From: Paul Mood
Sent: Friday, November 16, 2018 9:04 AM
To: Brian Dalke; Jeremy Knapp
Cc: Dawn Marie Buckland; Paul Michaud; Paul Mood
Subject: Lincoln Drive Median Access
Attachments: Lincoln Median Access - Engineering Dept. Review.pdf; ATT00001.htm; Lincoln Median Access Kimley Horn 3rd Party Review.pdf; ATT00002.htm

RE: Lincoln Drive Median Access from Mockingbird Lane to the Eastern Town Limits

Subject: Lincoln Drive, Mockingbird Lane to Town of Paradise Valley (TOPV) Jurisdiction
Median Breaks and Access
Third Party Traffic Review Comments

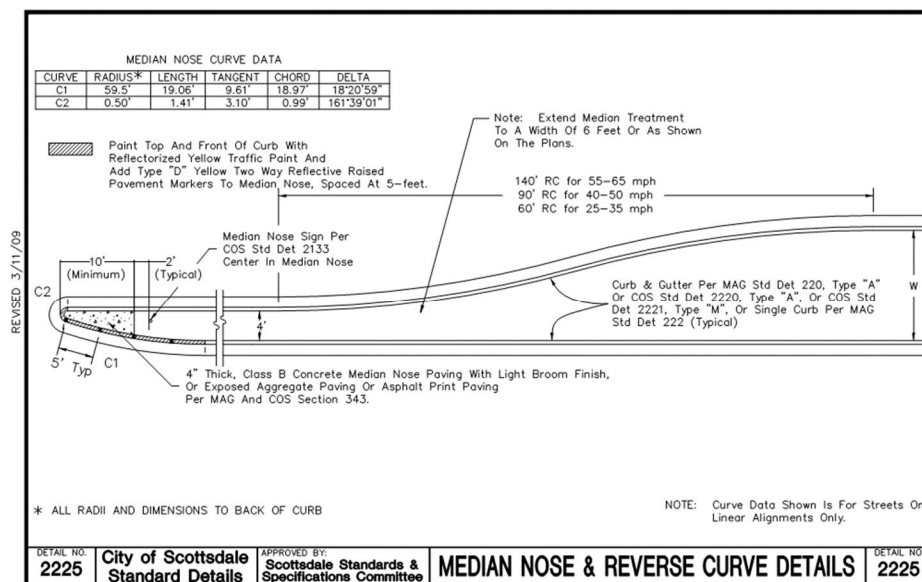
It should be noted that AASHTO also suggests that shorter tapers can be utilized in urban conditions when peak periods result in slower speeds. In this case and recognizing that the Town of Paradise Valley may follow the City of Scottsdale Standards, Kimley-Horn defaulted to the City of Scottsdale's, Design Standards & Policies Manual, 2018 and Standard Detail 2225 shown on the next page. Per the detail, a minimum taper of 90 feet should be provided for a 40 to 50 mph roadway.

KH Comment 8: Posted speed limit of Lincoln Drive within the project limits is 40 MPH. We recommend that at a minimum an opening taper length of 90 feet be provided at all left turn bays to allow for the deceleration and safe transition of vehicles from the through lane into the left turn lane.

Figure 4.2 Process for Selecting Average Rate or Equation
in Trip Generation Manual Data

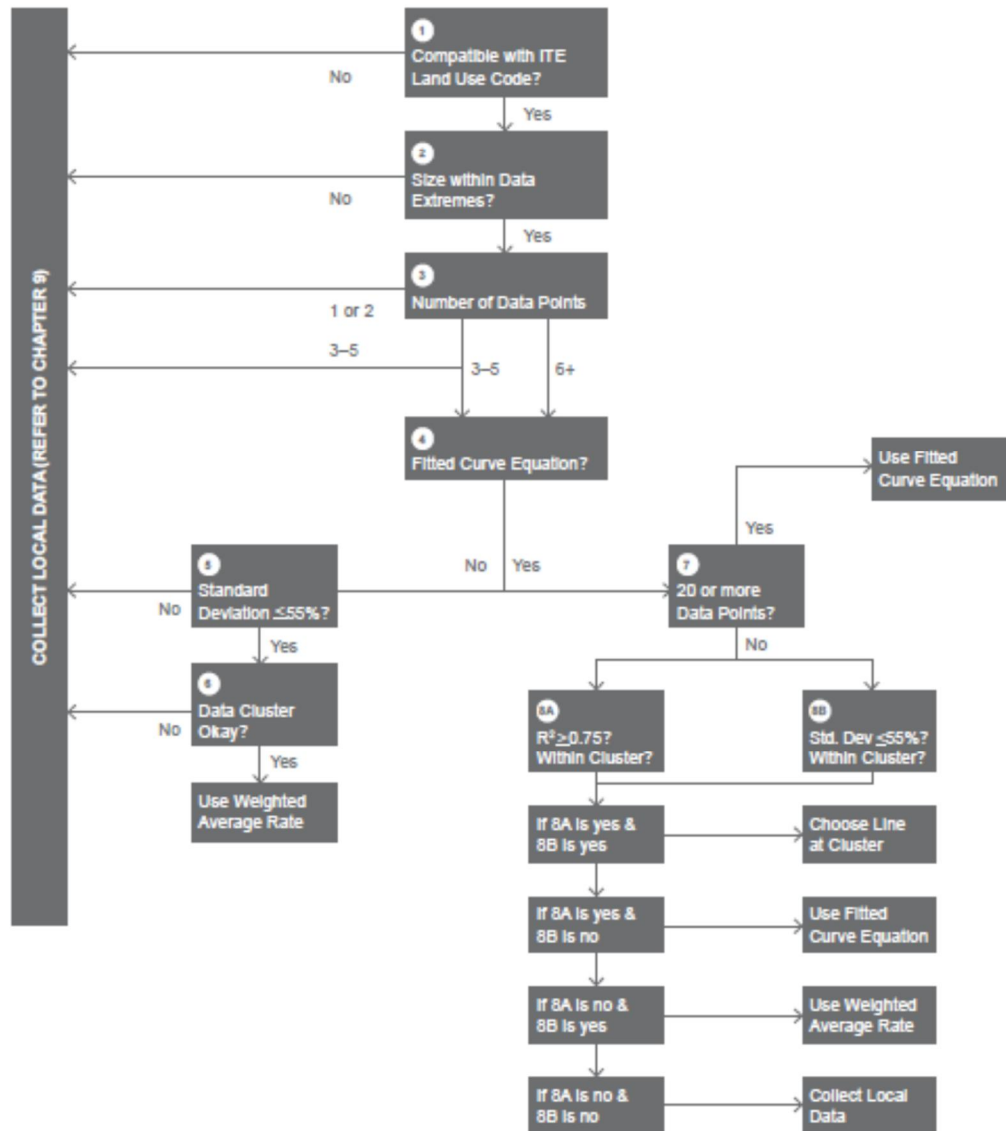
KH Comments 4: Smoke Tree Resort utilized equations as opposed to average rates. KHA went through the ITE Trip Generation Handbook process presented in Figure 4.2 assuming proposed number of units for resort hotel (LUC 330). The results of this process are presented below and KH redlines provided in **Appendix 1**.

Because the rooms are not within the data extremes and the R2 value is less than 0.75, we recommend the weighted rates be used. Using the rates as opposed to the equation results in double the trips being generated in the AM peak hour.

Response to Comment 4: CivTech has updated the trip generation rates to reflect a blended rate between LUC 310 and 330 as discussed in response to comment #3. The trip generation calculations were also revised to reflect 150 rooms, 30 residential units, and 3500 square foot quality restaurant. The revised trip generation calculations and approach were considered acceptable. The revised trip generation calculations, based on 150 rooms, 30 residential units, and 3500 square foot quality restaurant, are provided in **Appendix 2**.

Kimley-Horn Comments on
CivTech Access Assessment Option 1 through 3

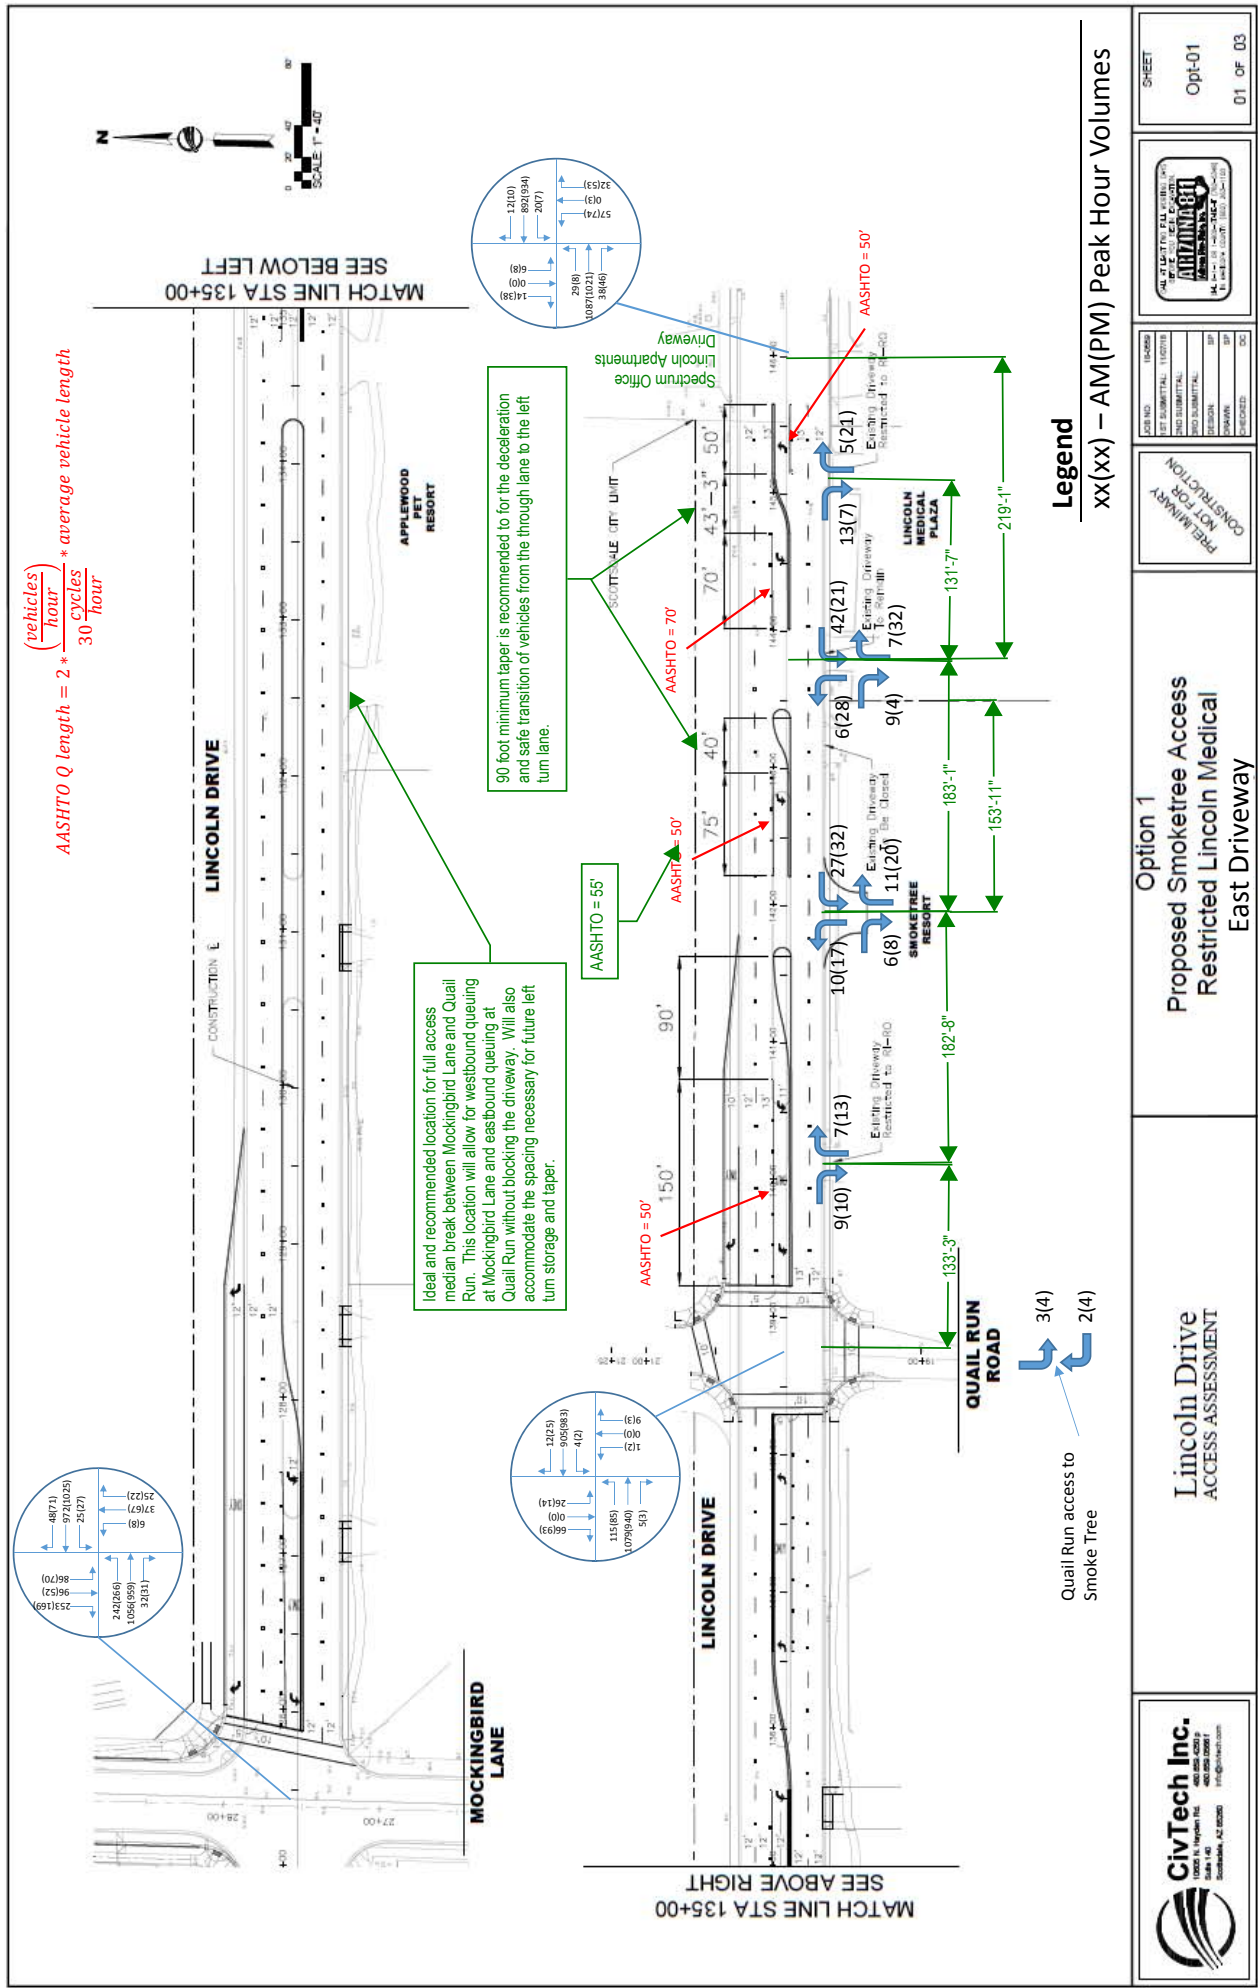
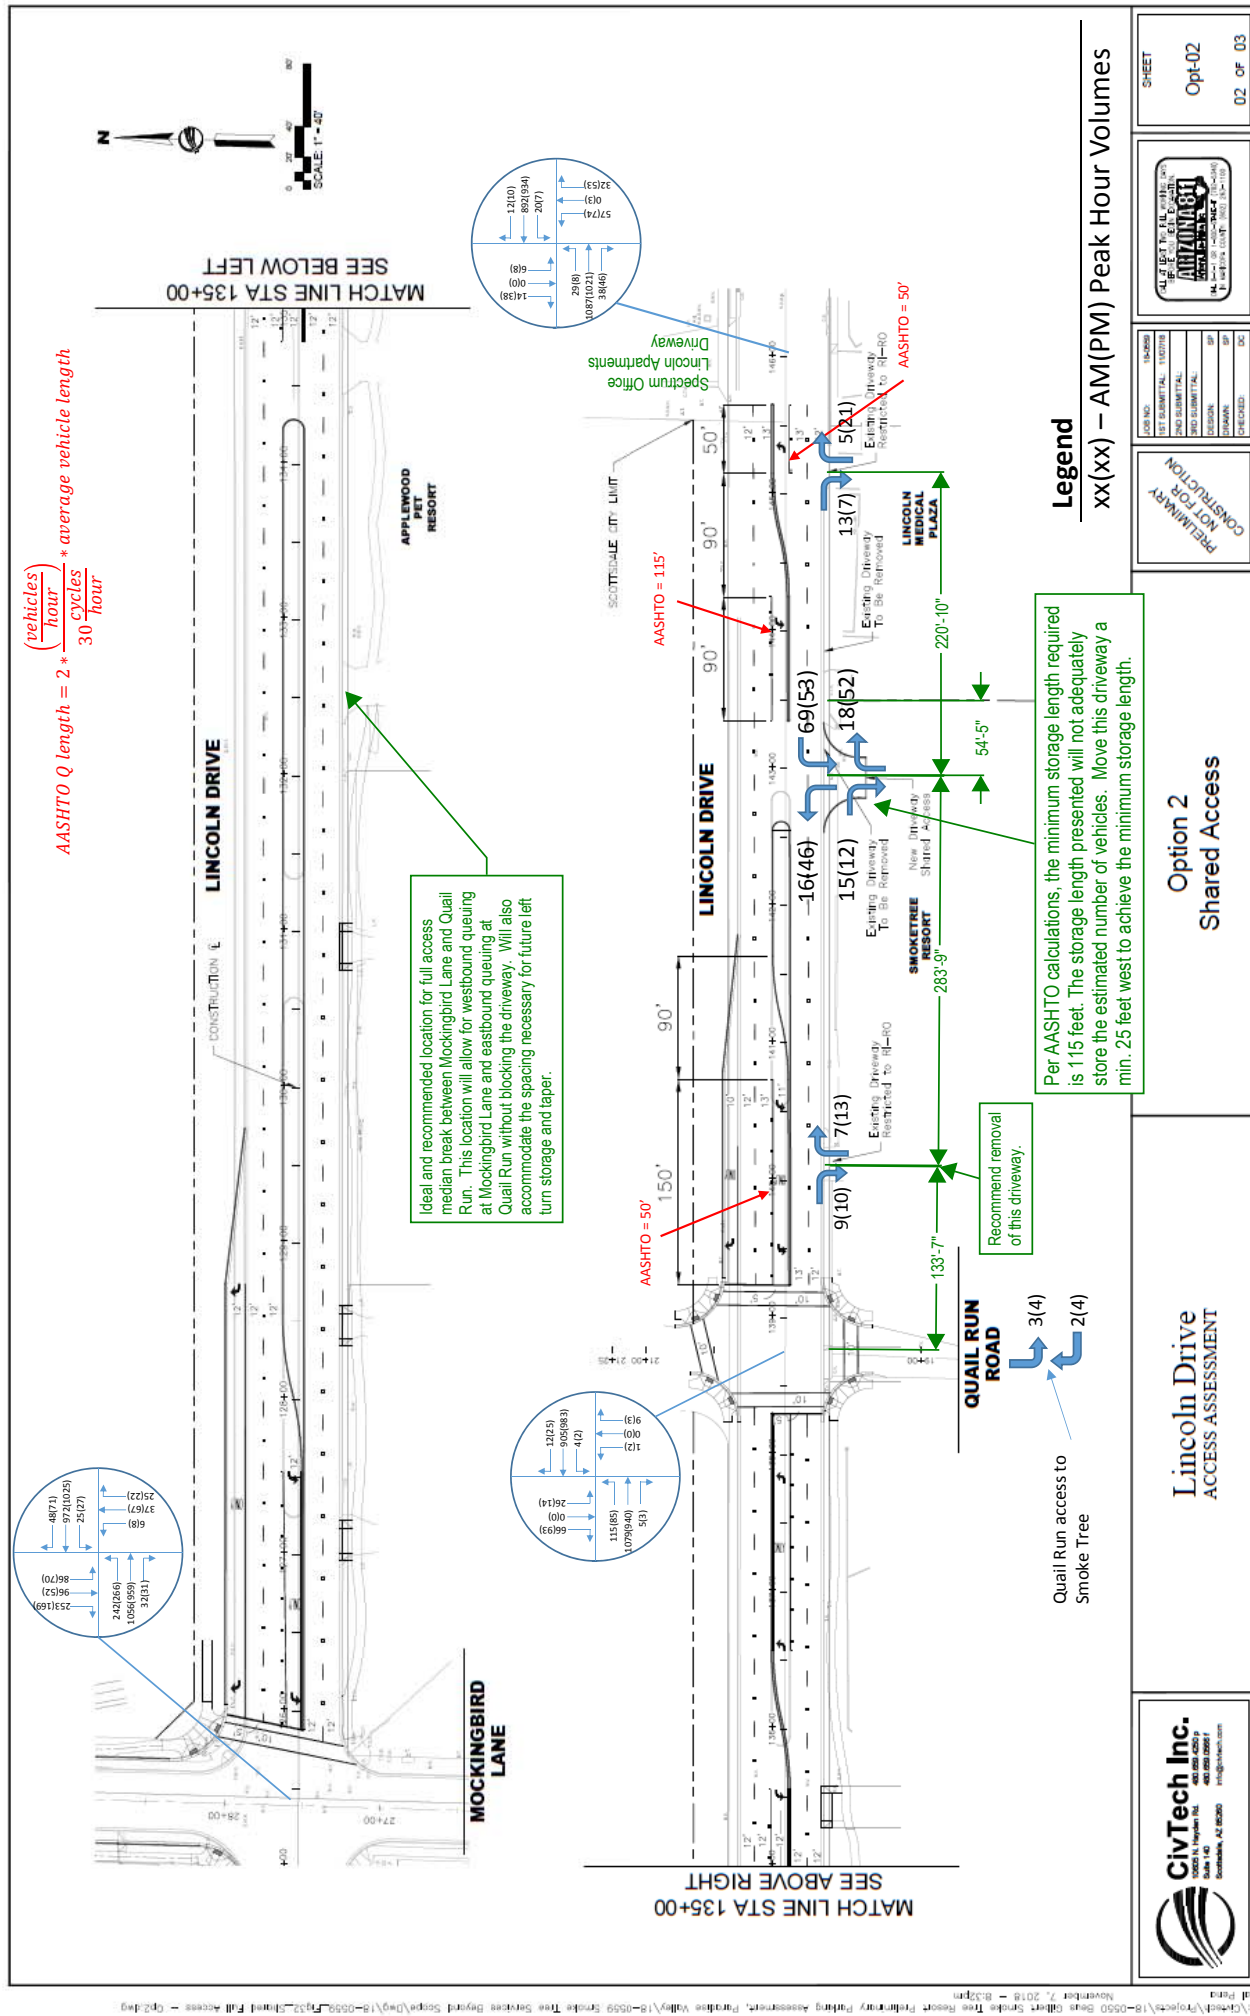
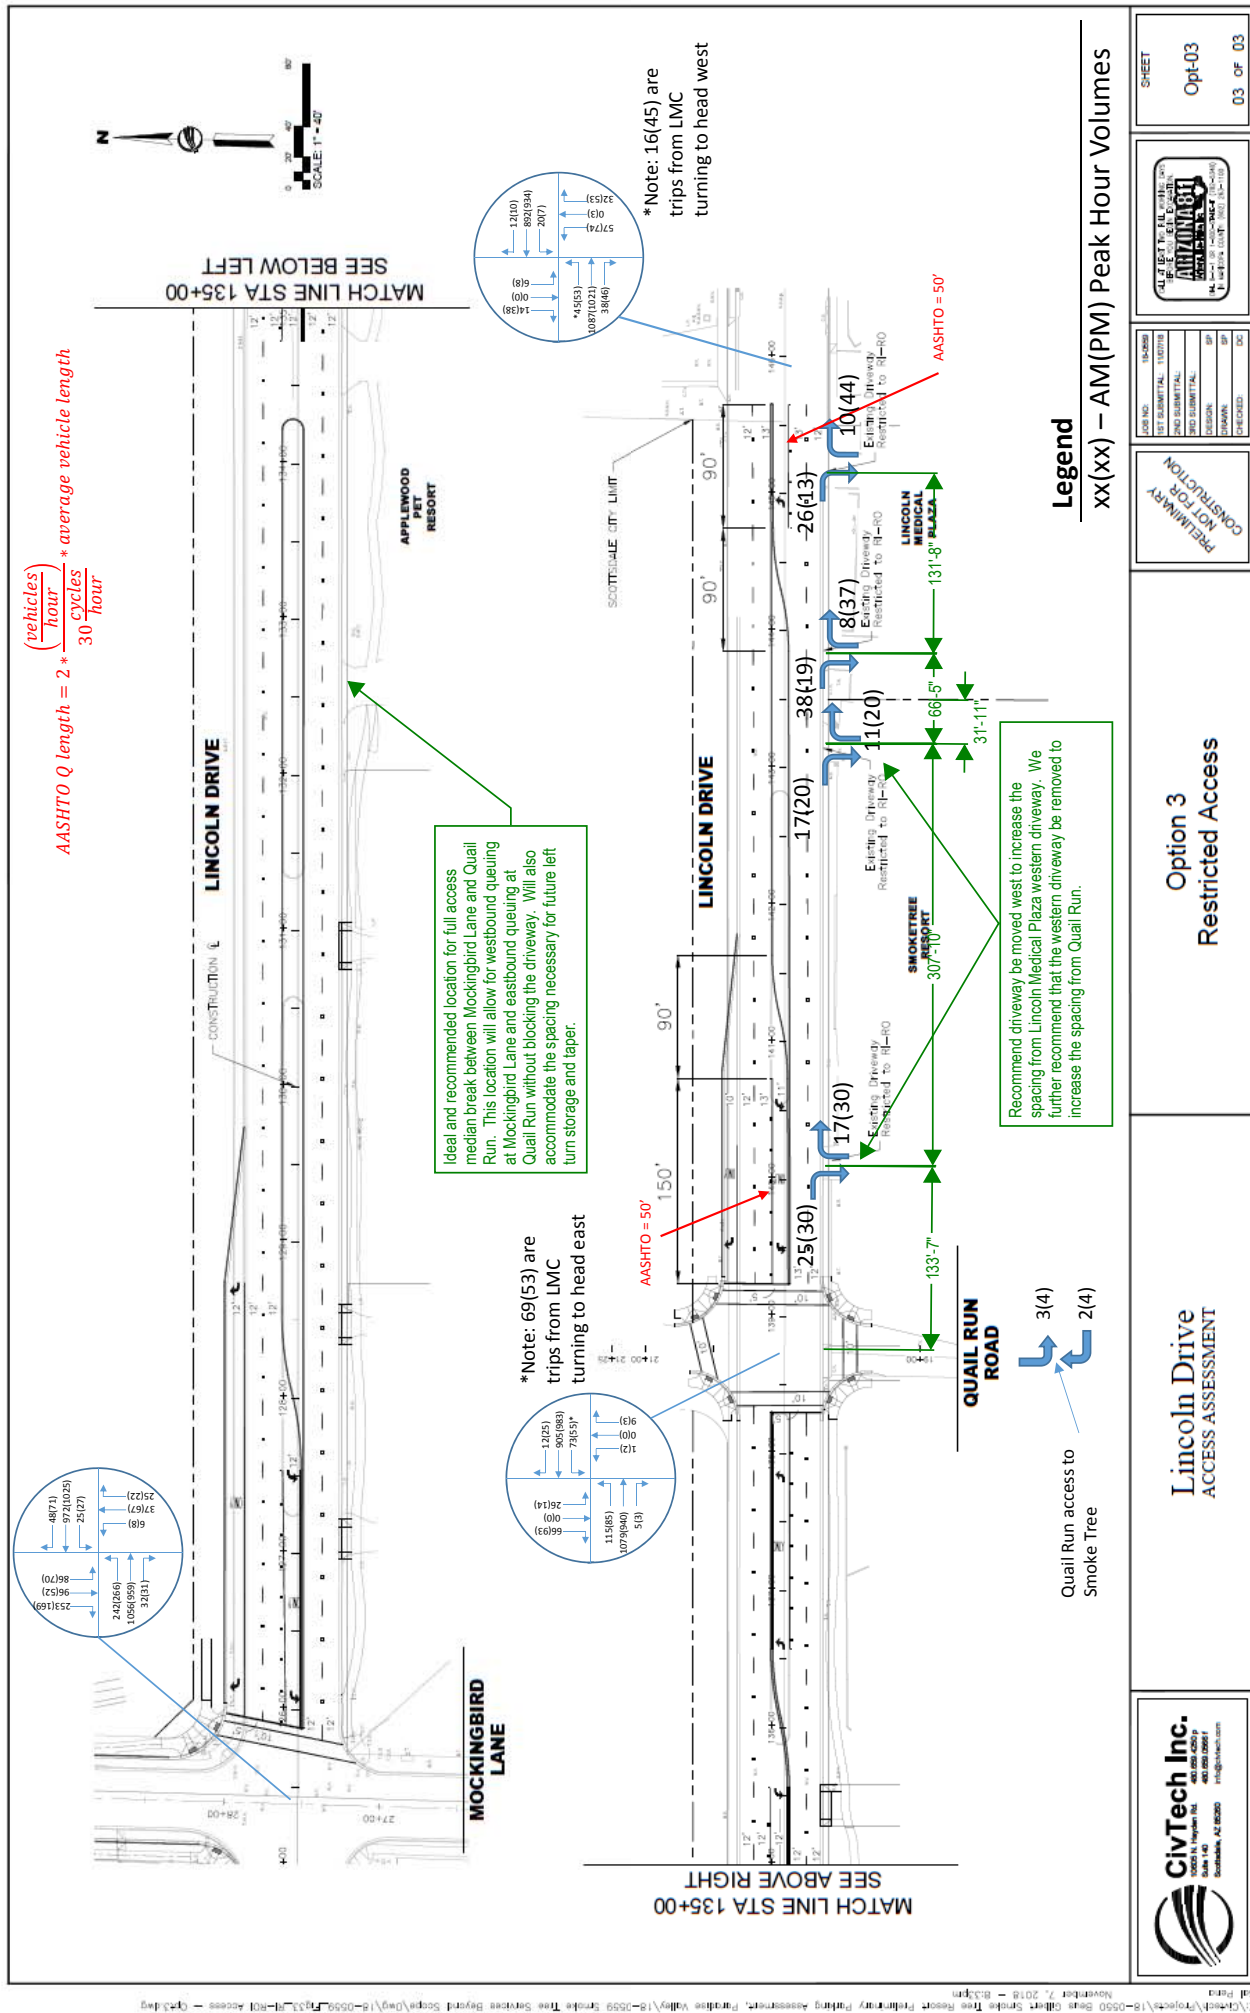
KH Comment 10: Storage length at Spectrum Office Driveway/AJ Driveway calculation ((29 vph x 25 feet x2)/30) is 48 feet. Per AASHTO, the minimum storage length is 50 feet. Exhibit illustrates a minimum of 50 foot being provided. This is considered acceptable.

KH Comment 11: As shown in Option #1 exhibit, access improvements include closure of the existing eastern access on Smoke Tree Resort, a new Smoke Tree Resort access approximately 183 feet west of Lincoln Medical Plaza access, and the existing Smoke Tree Resort western access to remain as right in/right out. The proposed improvements result in the following spacing (centerline to centerline) of driveways:

KH Comment 12: The storage length shown in Option #1 exhibit for Lincoln Medical Plaza is 70 feet. Per AASHTO calculations, storage length should be no less than 70 feet to adequately store the estimated number of vehicles generated by Lincoln Medical Plaza. This is considered acceptable. The storage length for the Smoke Tree Resort eastern driveway is 75 feet. Per AASHTO calculations, storage length should be no less than 55 feet to adequately store the estimated number of vehicles generated by the Smoke Tree Resort. This is considered acceptable.

KH Comment 13: As shown in Option 1 exhibit prepared by CivTech, opening bay tapers are 40 feet at Smoke Tree Resort and 43-3" feet at Lincoln Medical Plaza. KH recommends that no less than a 90-foot opening taper be utilized to safely traverse traffic from the through lane to the left turn lane on Lincoln Drive, per the criteria and discussion on Page 4, 5, and 6 of this document. Kimley-Horn recommends the median be extended and access points to Lincoln Medical Plaza be restricted to right in/right out only movements for two reasons:

KH Comment 14: As shown in Option #2 exhibit, access improvements include closure of the western Lincoln Medical Plaza access, a new shared access for the Smoke Tree Resort / Lincoln Medical Plaza approximately 55 feet from the shared Smoke Tree Resort / Lincoln Medical Plaza parcel line, and right in/right out to all other access points between Quail Run and TOPV jurisdictional boundary line. The proposed improvements in this option result in the following spacing (centerline to centerline) of driveways:

KH Comment 15: As shown in Option 2 exhibit prepared by CivTech, opening bay taper to the shared Smoke Tree Resort and Lincoln Medical Plaza is 90 feet. This is considered adequate.

KH Comment 16: The storage length shown in Option #2 exhibit for the shared Smoke Tree Resort/Lincoln Medical Plaza access is proposed at 90 feet. Per AASHTO calculations, storage length should be no less than 115 feet to adequately store the estimated number of vehicles generated by

KH Comment 17: *As shown in Option #3 exhibit, all existing driveways between Quail Run and eastern Lincoln Medical Plaza access points, will remain and be restricted to right in/right out only. This results in the following spacing (centerline to centerline) between the existing driveways:*

KH Comment 18: *This option does provide the safest option by removing the conflict points that would occur with left in/left out maneuvers. It should be noted that Lincoln Drive does not provide enough pavement width necessary to safely make U-turn maneuvers. Providing an access point that is located to safely transition and adequately store the estimated left turn volumes will reduce the need for U-turn maneuvers. Allowing shared access between the Smoke Tree Resort and Lincoln Medical Plaza parcels would remove the need for any U-turn maneuvers. For this option, should it be determined that shared access will not be provided, Kimley-Horn recommends U-turns be restricted.*

Smoke Tree Resort and Lincoln Medical Plaza. For this option, the shared access should move a minimum of 25 feet west of the location shown in the CivTech exhibit to accommodate the minimum storage length necessary to adequately store the estimated left turn volumes without spilling back into Lincoln Drive through lanes. This would result in placing the shared driveway a minimum of 80 feet from the Smoke Tree resort/Lincoln Medical Plaza parcel line.
